PLAN NO. 2800
LOT KITSAP DCD 5FR BASIC
TAX ID*
P.O. BOX 3631 SILVERDALE, WA 98383
(360) 779-4668 f (360) 620-8883 c
FERGUSONCOLE.COM

NEW HOMES  
FERGUSON & COLE, INC.

DRAWING:  
FLOOR PLANS

BASIC PERMIT PACKAGE  
REVIEWED FOR CODE COMPLIANCE  
WITH IRC 2015  
KITSAP COUNTY BUILDING DEPARTMENT  
07/30/2018 11:23:17 AM  
# [18-02763]

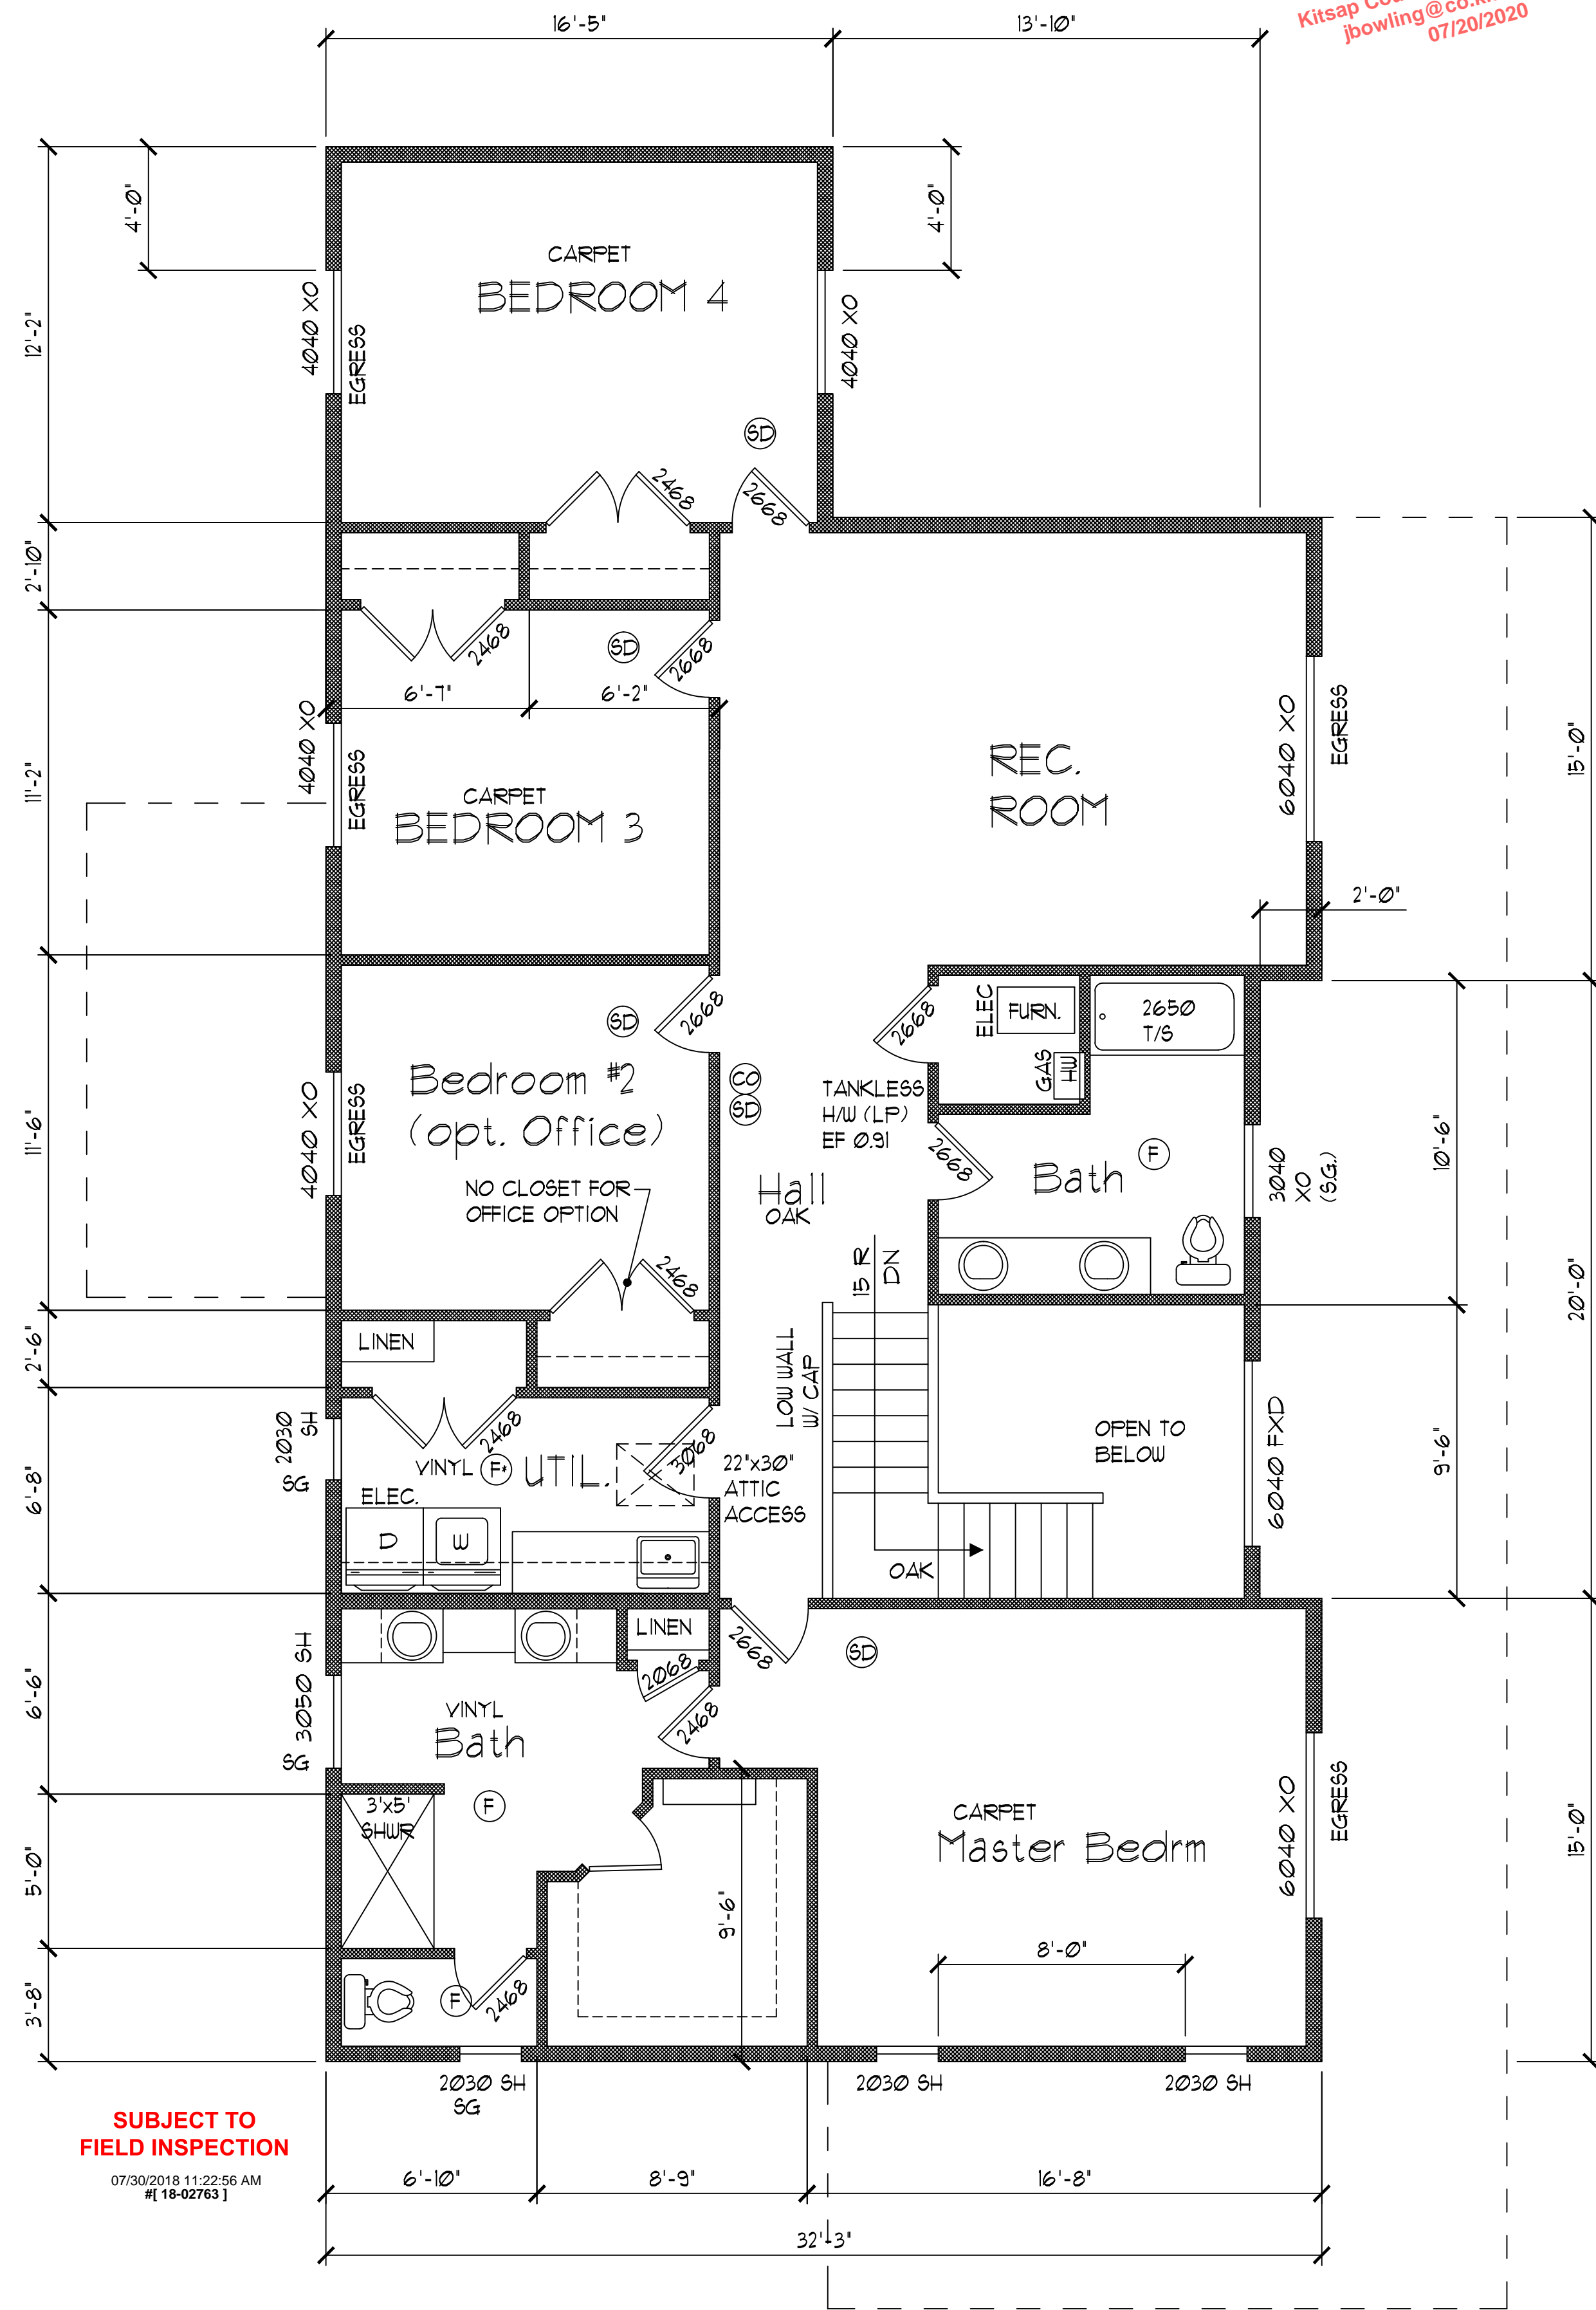
SMOKE ALARM NOTE:  
- INSTALL SMOKE ALARM 10' FROM OVEN.  
ALARM SHALL HAVE SILENCING BUTTON OR  
PHOTOELECTRIC TYPE IF LESS THAN 20'
